MESA DEL SOL
ARCHITECTURAL CONTROL COMMITTEE
SITE DEVELOPMENT PLAN REVIEW

MESA DEL SOL SELF STORAGE
SITE PLAN
5500 TURING DR SE
ALBUQUERQUE, NM 87106
PROJECT #2322

**RE: Mesa Del Sol Self Storage
5500 Turing Dr. SE
Grading and Drainage Plan
Engineer's Stamp Date: 5/7/2025
Hydrology File: R16DA1004**

**Re: Mesa Del Sol Self Storage
 5500 Turing Dr. SE
 Grading and Drainage Plan
 Engineer's Stamp Date: 01/15/2025
 Hydrology File: R16DA1004**

PROJECT NUMBER

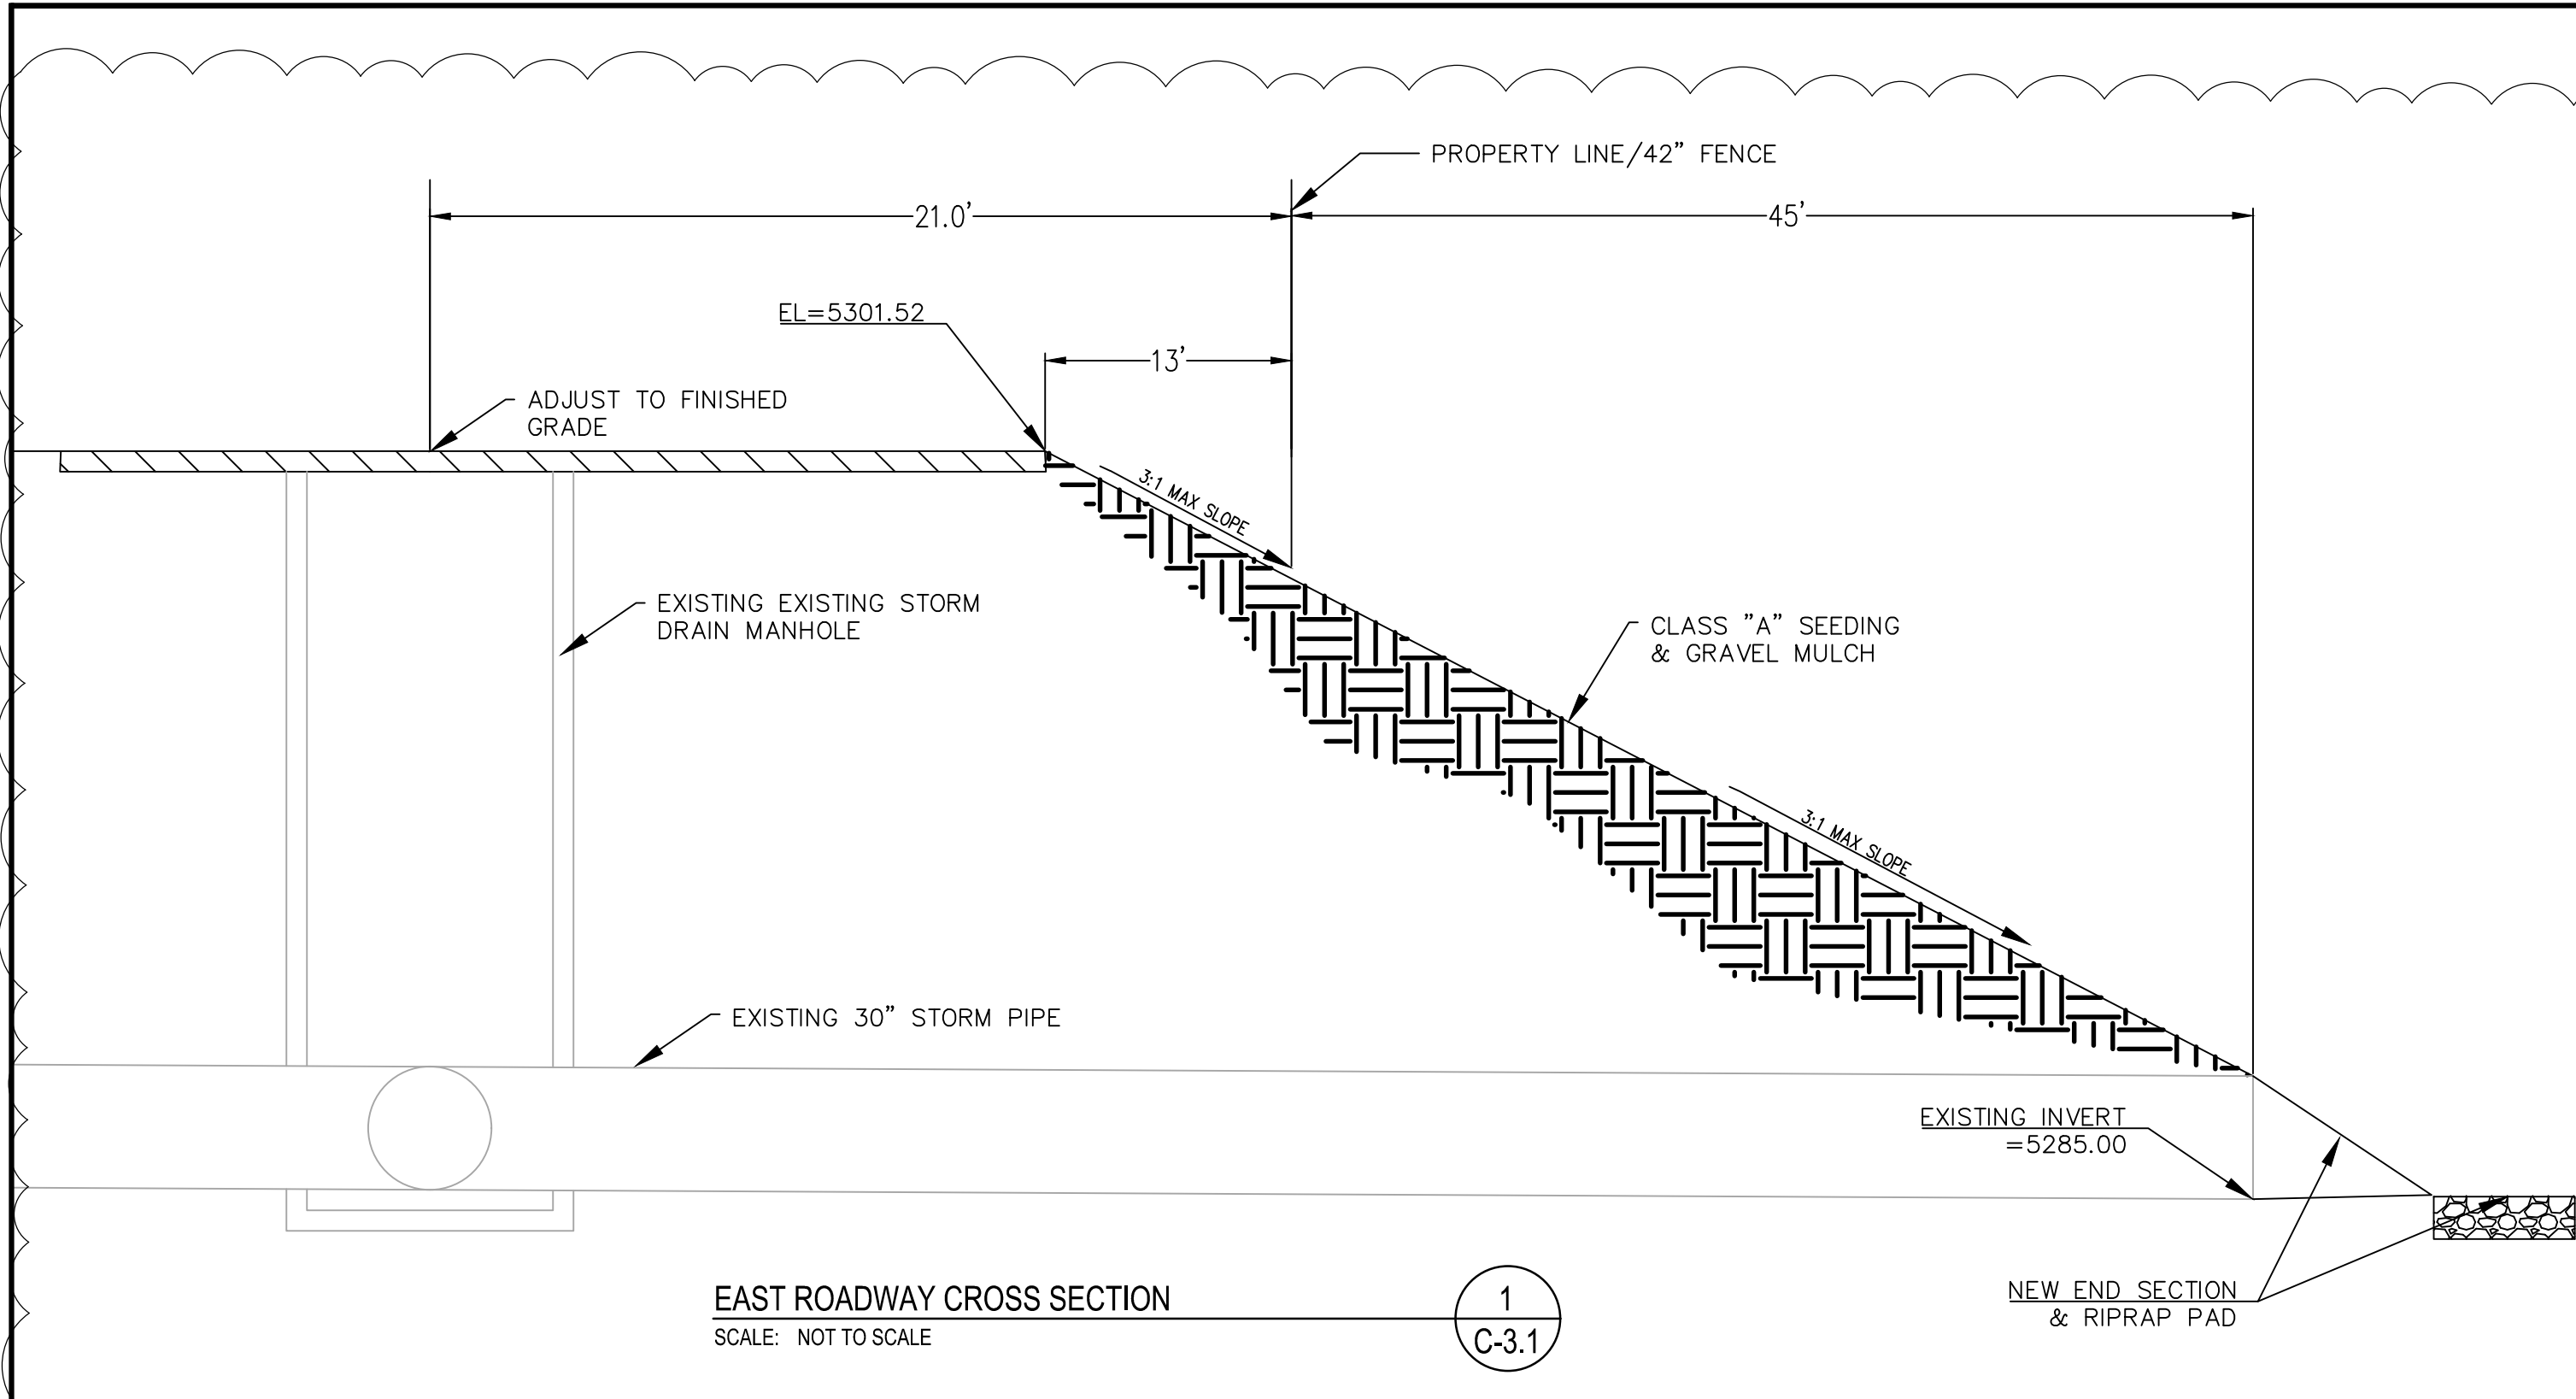
REVISIONS	NO.	BY	DATE	REMARKS
	1	NV5	5/7/25	HYDROLOGY COMMENTS DATED 3/21/25

CIVIL DETAILS.		CIVIL DETAILS	
PROJECT NUMBER	DRAWING FILE NAME	SCALE	SHEET NUMBER
			C-3.1

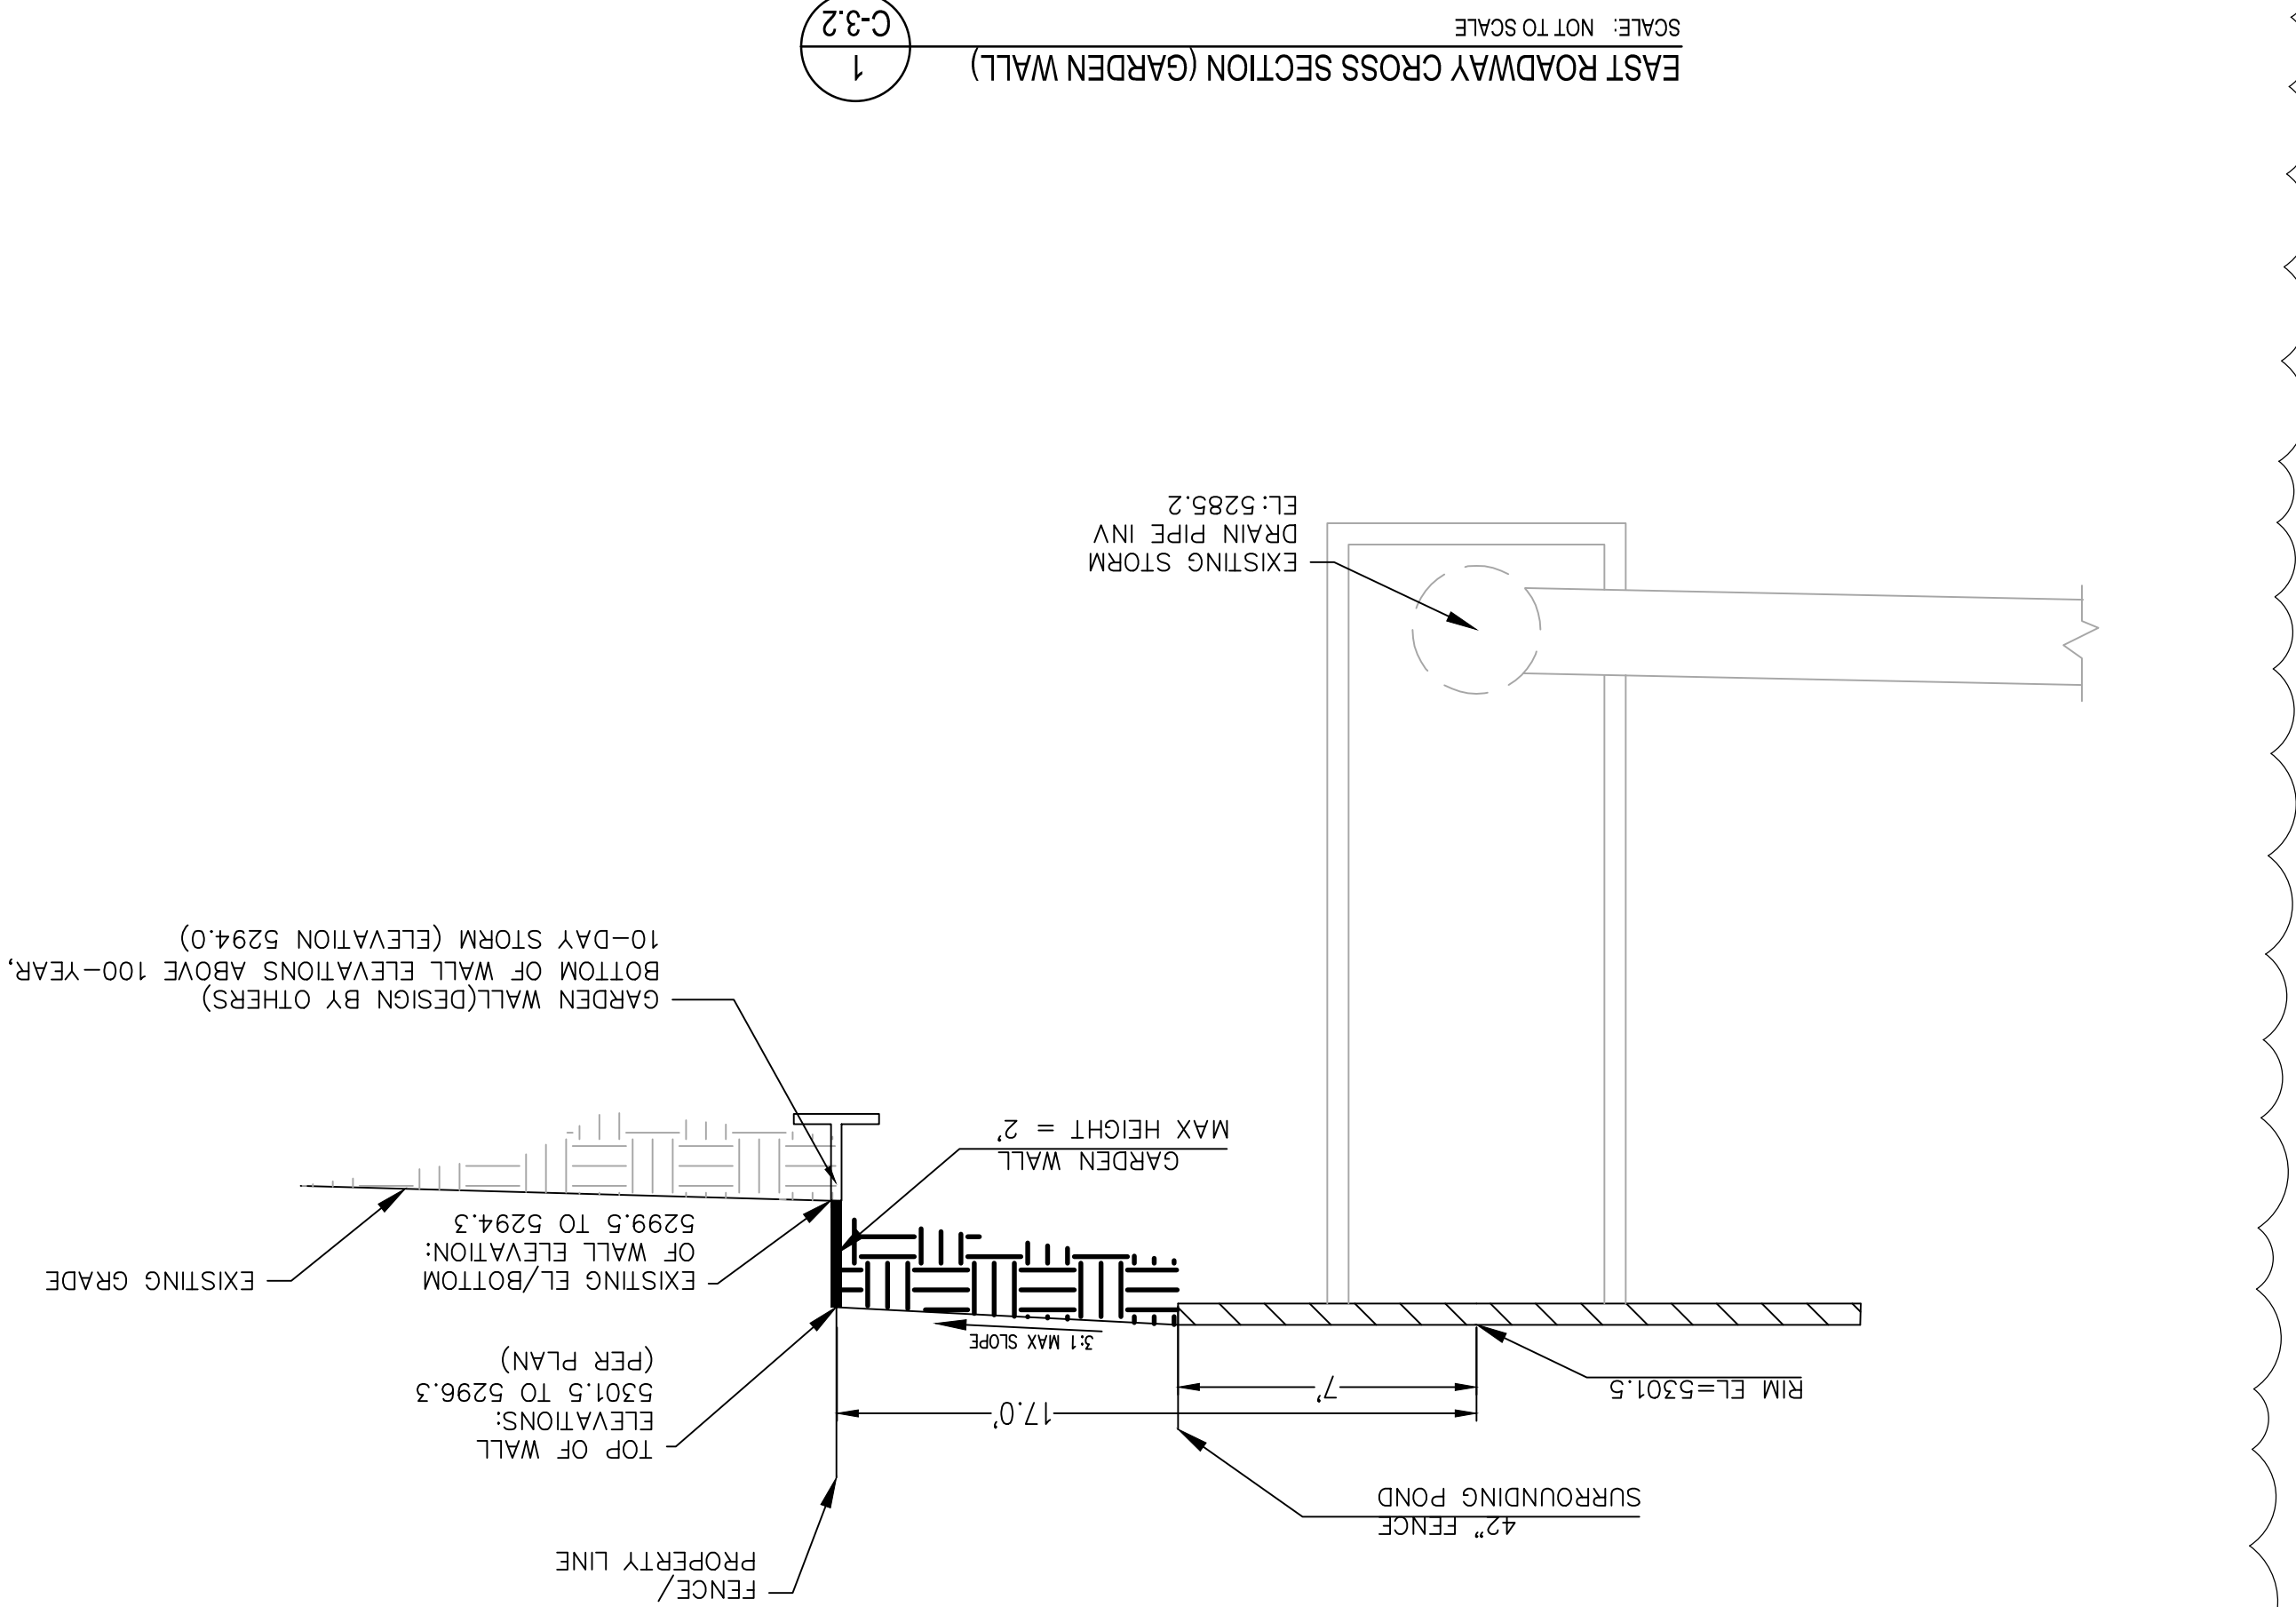
8. Due to the proposed retaining wall in Section 1 of C-3.1, provide an additional cross-section showing the existing storm drain manhole and pipe extension through the proposed retaining wall and into the retention basin at the southeast corner of the project.
Concur. Additional section has been added, see revised sheet C-3.1 & C-3.2. Retaining wall removed from revised design.
